Safety Recall

N242441392 Right Side Seatbelt Retractor May Lock

Release Date: September 2024

Revision: 02

6682025

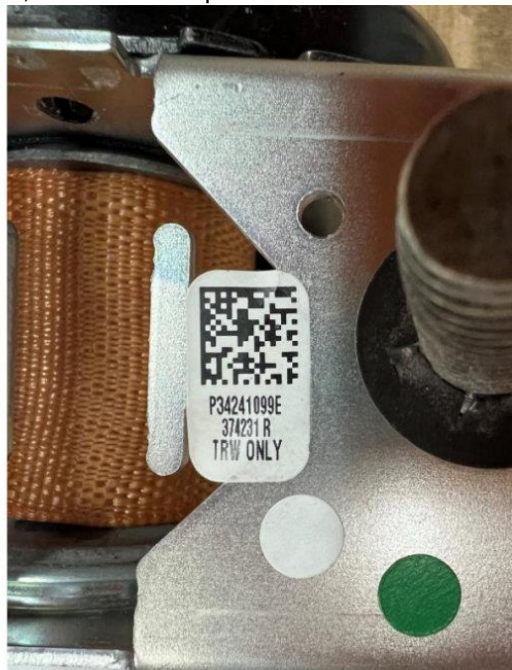
1. Inspect the NEW Seatbelt Retractor label located on the bottom of the Seatbelt Retractor.
 - If the 4th and 5th digits are "23" AND the 1st and 2nd digits range between "35"- "52", " , The part is BAD and MUST be scrapped. DO NOT INSTALL ON VEHICLE. Reference the Scrap Instructions below. Re-order a replacement Seatbelt Retractor and repeat inspection.
 - If the 4th and 5th digits are "23" AND the 1st and 2nd digits DO NOT range between "35"- "52" proceed to Step 3.
 - If the 4th and 5th digits are "24", Proceed to Step 2.

6682025

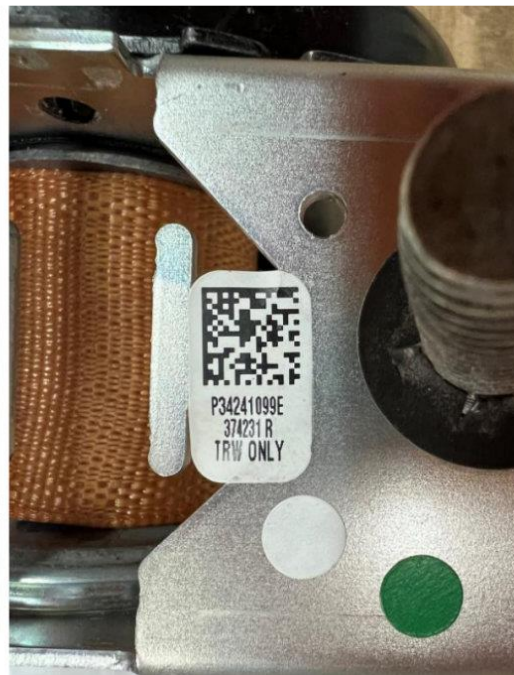
2. Continue to inspect the NEW Seatbelt Retractor label located on the bottom of them retractor.
 - If the 4th and 5th digits are "24" AND the 1st and 2nd digits are "01", ", The part is BAD and MUST be scrapped. DO NOT INSTALL ON VEHICLE. Reference the Scrap Instructions below. Re-order a replacement Seatbelt Retractor and repeat inspection.
 - If the 4th and 5th digits are "24" AND the 1st and 2nd digits are NOT "01" proceed to Step 3.
3. Replace the RH Front Seat Belt Retractor. Refer to *Front Seat Belt Retractor Replacement* in SI. If convertible, refer to *Front Seat Belt Retractor Replacement - Right Side (Convertible)* in SI.
4. Scrap all replacement Seat Belt Retractors that failed inspection steps 1 and/or 2 AND the used Seatbelt Retractor. Refer to the Scrap instructions below.
